APPLICATION NO.	FILING DATE	FIRST NAMED INVENTOR	ATTORNEY DOCKET NO.	CONFIRMATION NO.
10/779,471	02/13/2004	Bradford G. Baruh	033151-026	5526

Office Action Summary	Application No. 10/779,471	Applicant(s) BARUH, BRADFORD G.	
	Examiner AARON DUNWOODY	Art Unit 3679

DETAILED ACTION

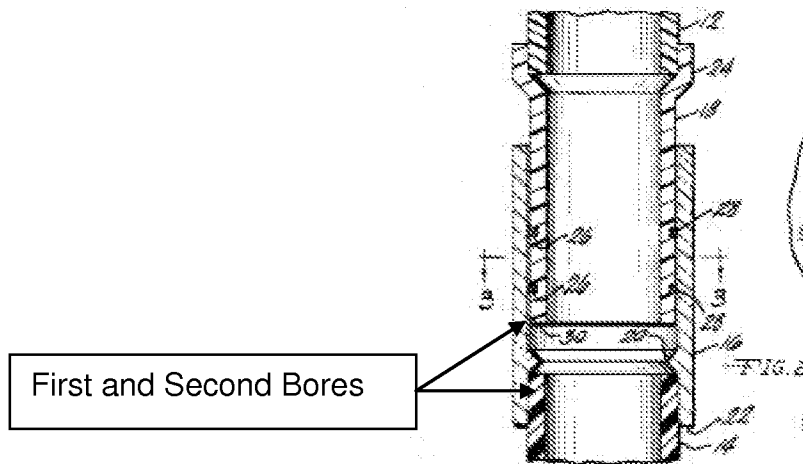
In regards to claim 1, Williams discloses a pipe coupling (16) comprising: an elongated housing having a first end and a second end, the housing defining an elongated bore therein; a stop (20) located on an inner diameter of the housing, the stop located between the first end and the second ends of the housing, wherein a distance from the stop to one of the first and second ends is at least two times a distance from the stop to the other of the first and second end of the housing; a first cylindrical bore extending from the first end to the stop; and a second cylindrical bore extending from the second end to the stop, and wherein each of the cylindrical bores are configured to allow a pipe end to advance into the pipe coupling until reaching the stop.

Williams does not disclose an angle between the first cylindrical bore and the second cylindrical bore is about 15 degrees to about 165 degrees. Waterhouse teaches couplings (1, 5, 6, 9, 13, 14) with an angle between a first cylindrical bore and a second cylindrical bore being about 15 degrees to about 165 degrees, to employ different angles for conventional plumbing (col. 1, lines 45-57). As Waterhouse relates to geometrical structures using plumbing joints, it would have been obvious to one having ordinary skill in the art at the time the invention was made to fabricate couplings with an angle between a first cylindrical bore and a second cylindrical bore being about 15 degrees to about 165 degrees, to employ different angles for conventional plumbing, as taught by Waterhouse.

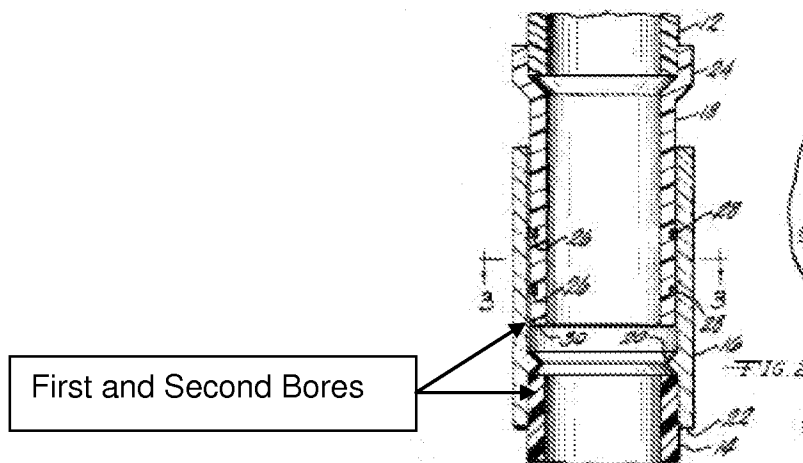
In regards to claim 29, Williams discloses the stop being a single stop located on the inner diameter of the housing.

In regards to claim 30, Williams discloses the stop being a single stop located on the inner diameter of the housing.
